Comments on the SDSEIS: Environmental Impacts

Mark Nagel,
Marina Community Association

Figure 1. SFMOMA Total Visitors, 2006 - 2008

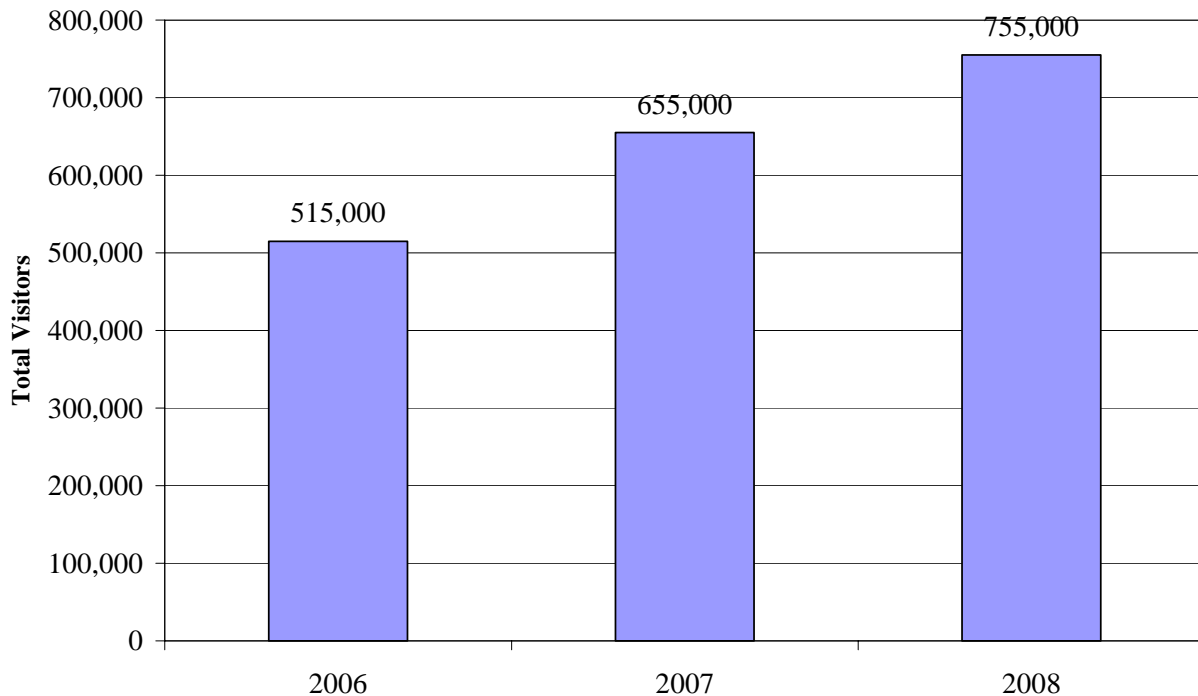
To draw out the implications of the comparison of CAMP with SFMOMA, Figure 1, below, shows the total visitation to SFMOMA during 2006 to 2008. With a focus on modern and contemporary art, SFMOMA is the San Francisco museum that is most comparable to CAMP. SFMOMA has seen a striking growth in total visitation, from 515,000 in 2006, to 655,000 in 2007, to 755,000 in 2008. These impressive visitation numbers demonstrate the ability of a contemporary art museum to attract large crowds. SFMOMA has only 50,000 square feet of gallery space, which is almost identical to the proposal for CAMP.

With the same amount of gallery space and a similar style of art, SFMOMA in 2008 attracted almost double the number of visitors projected as the upper threshold for CAMP. For the past two years, SFMOMA’s total visitation has been significantly higher than the maximum visitation projected for CAMP. The above analysis suggests that the SDSEIS has underestimated the daily visitation for CAMP. Because the daily visitation projection is the main driver of many of the analyses in the SDSEIS, it is necessary to evaluate and potentially revise the analysis in the SDSEIS.

Figure 2. Weekend vs. Weekday Visitation at the de Young and Legion of Honor, July 2006 – June 2008

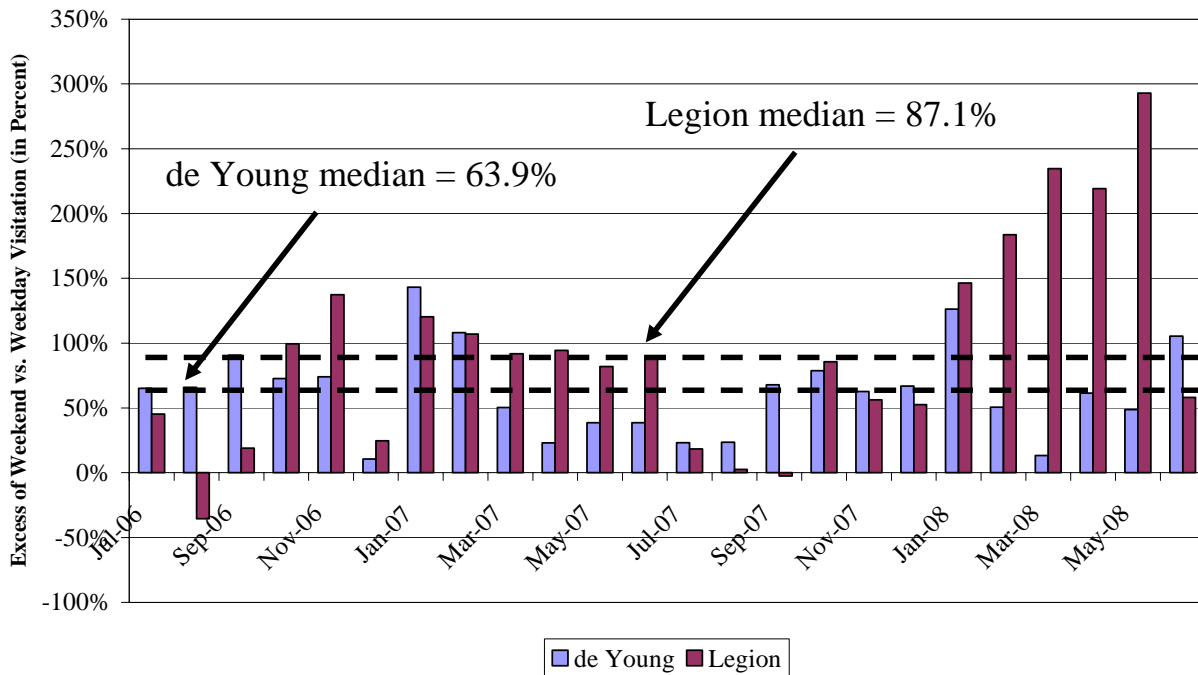
Visitation to museums is substantially higher on the weekends than on weekdays. Figure 2, below, shows the percentage difference between weekend and weekday visitation at the de Young and Legion of Honor over a two-year period. During this period, weekend visitation was 63.9% higher at the de Young and 87.1% higher at the Legion of Honor than on weekdays. The data shows variation around these medians, with some months having even higher weekend visitation. Less complete data from SFMOMA shows a similar pattern, with weekend attendance 35.1% higher on the weekend than on weekdays.¹¹

This analysis underscores the importance of considering both weekends and seasonality. Figure 2 visually demonstrates that weekend visitation, especially in the summer and fall, consistently produces daily visitation rates that would significantly exceed the assumed level for CAMP. Median daily weekend visitation to the de Young in the summer of 2007 was 65.5, while median winter weekday visitation in the winter in 2007-2008 was 31.1. The summer peak was 110% greater than the winter low.

Figure 3. Weekend and Weekday Visitation at the de Young, July 2006 – June 2008

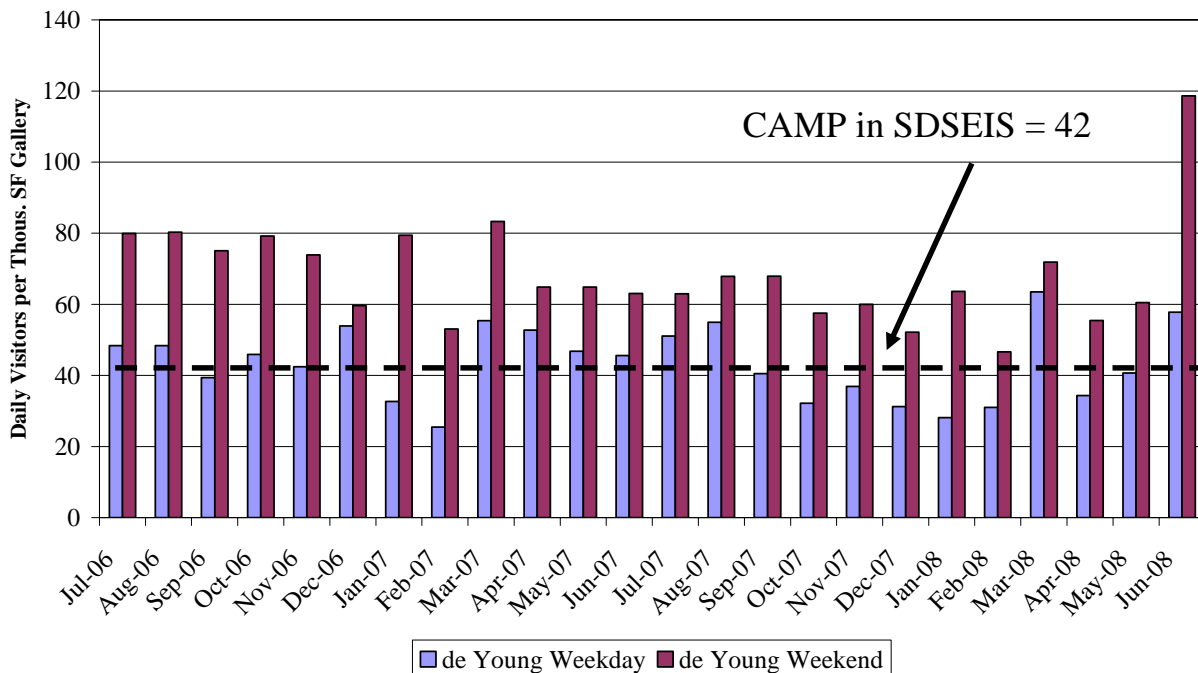
The analysis of the SDSEIS needs to reconsider the decision not to include an analysis of weekend and seasonal visitation. The analysis should determine whether the increase in visitation from some uses, such as the museums and other recreational activities, would exceed
